ADA Compliance Program

Clark County Facilities Transition Plan Franklin Building

Date of Survey: July 10, 2006
 Conducted by: Clark County Citizen ADA Advisory Committee
 Wayne Yarnall Bud Van Cleve Teresa Guise (Absent)
 Connie Brittain Jesse Magana Tim McVicker

Item # 6

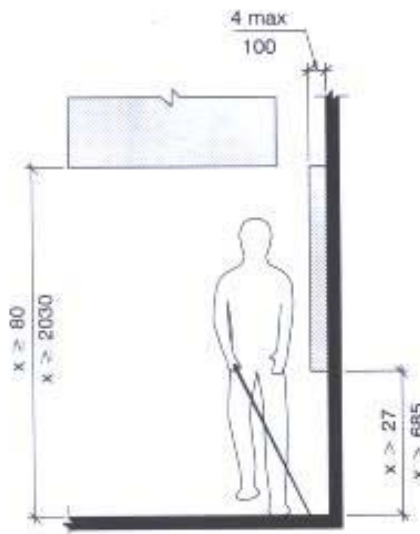
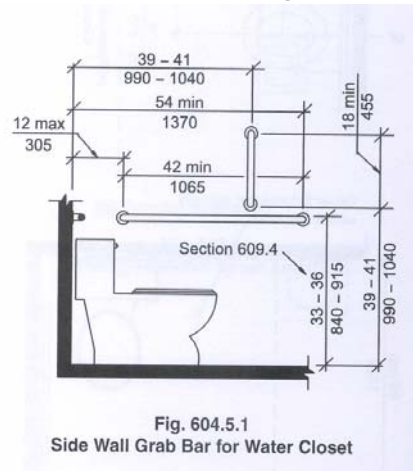
Issue: Drinking Fountain– Protrusion Limits

Location: First Floor of Franklin Building

Code: ANSI 307.2 Protrusion Limits. Objects with leading edges more than 27 inches and not more than 80 inches above the floor shall protrude 4 inches maximum horizontally into the circulation path. The drinking fountain shown protrudes significantly into the hallway and the height exceeds the 27 inch minimum.

The fountain should be recessed into an alcove or protected by cane detectible barriers.
